## Service Information for Broadcast Equipment

Date: 14/03/2003	Manual: 7 inch Viewfinder LDK 4019/00	No: SI	0889
Subject: HD - Deflection FETS somtimes defect at power up		<u>Sh:</u> 3	Sheet: 560 - 1

**Subject:** 8926 401 90001 7 inch Viewfinder

## On deflection board 3922 406 88691:

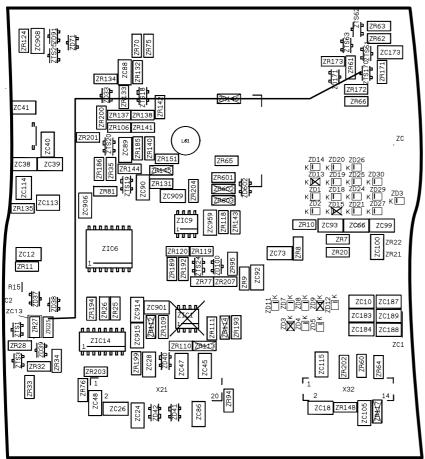
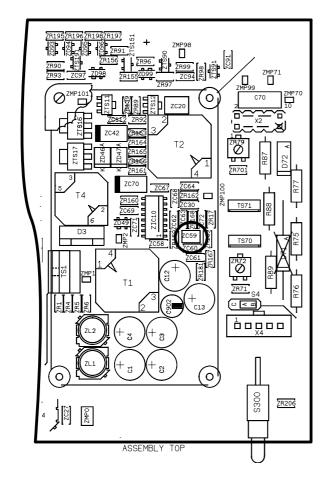
Problem: HD - Deflection fets (Ts63 and Ts64) sometimes defect at power-up system

**Result:** No picture output and no camera communication

- Remove screening cap on the bottom side of this board.
- Remove wire between ZR225 and pad left from ZC43
- Replace ZR225 from 100K in to 220K (partnr:2322 724 22204)
- Remove ZC3
- Remove ZR16
- Replace ZR38 from 100K in to 470K (partnr: 2322 724 24704)

Connect wire between ZR225 and collector ZTS170. Do not replace screening cap.

Remove screening cap on the top side of the board.

Replace ZC59 from 470nF into10nF

(partnr: 2222 892 10463) Replace screening cap.

Deflection board 3922 406 88691 will now have status 11.
